VERIFICATION REPORT

4×50MW Dayingjiang-3 Hydropower Project Phases 1&2

Project Title	4×50MW Dayingjiang-3 Hydropower Project Phases 1&2
Version	0
Report ID	JCI-VCS-VER-12/001

Figure 1 Revised Monitoring System

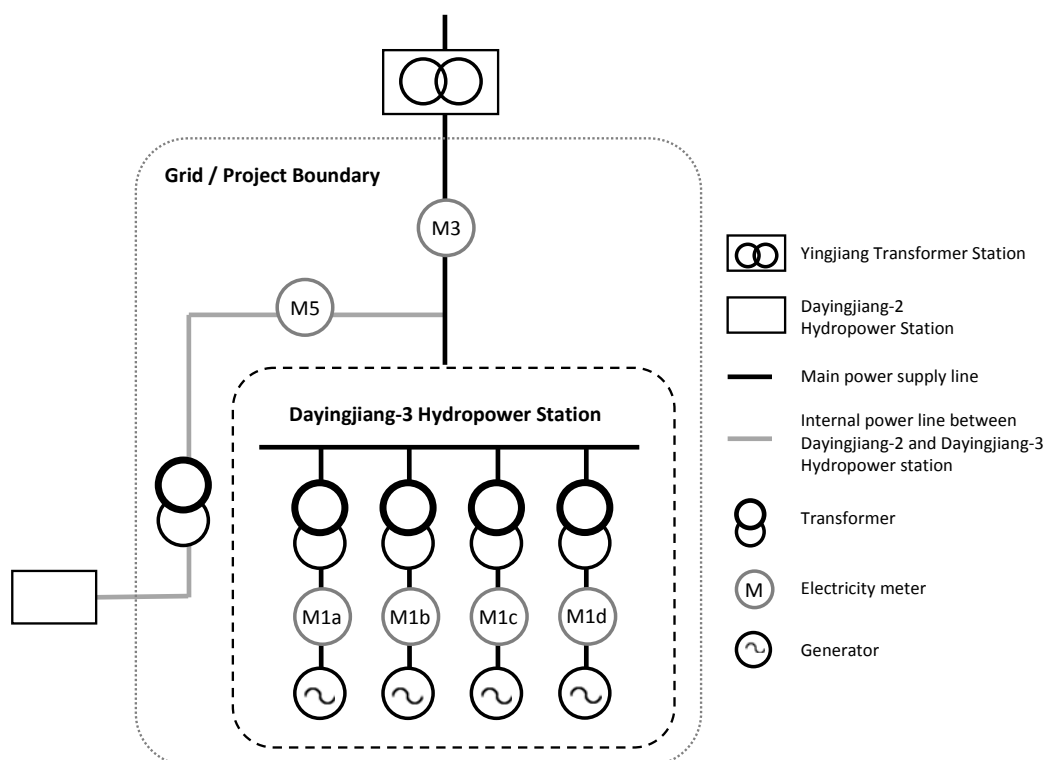
Originally M2 and M4 meters which are described as the backup meters for this project are actually possible to be used as the backup meters. However, both the meters are confirmed to be used for measuring the reactive power, not the active power at each point. Therefore the actual electric power supplied from this project is measured by M3 and M5 and, when there is some trouble on M3 and M5 meters, the emission reduction is calculated based on the invoice data measured by the grid company. The detail of this change can be referred to the section 3.3 Description of the monitoring report.

No. of request	CL-3
Clarification request	MR 3.3. Description of the Monitoring Plan As same as CL-2, Figure 1 does not show the actual configuration due to change of the monitoring devices.
Reference	
Summary of project owner response	The description of M2 and M4 in the Figure 1 is deleted.
Verification team conclusion	Figure 1 has been revised appropriately to show the actual configuration of monitoring devices. CL-3 was resolved and closed.

In case of the deviation of the project, it is a deletion of backup meter from the monitoring plan. The deviation impacts only on accuracy of monitoring results but the power sale invoice base on measurement of the grid company can be used for crosscheck of main meter measurement and also for calculation of emission reduction when the main meter is failed.

JCI concluded that the deviation was acceptable in accordance with the VCS requirement since it was in compliance with the applied methodology. And also JCI confirmed that the project proponent described and justified the deviation in the monitoring report appropriately. JCI concluded that the deviation was documented in the monitoring report appropriately in recognition of the deviation being a more limited change to the project.
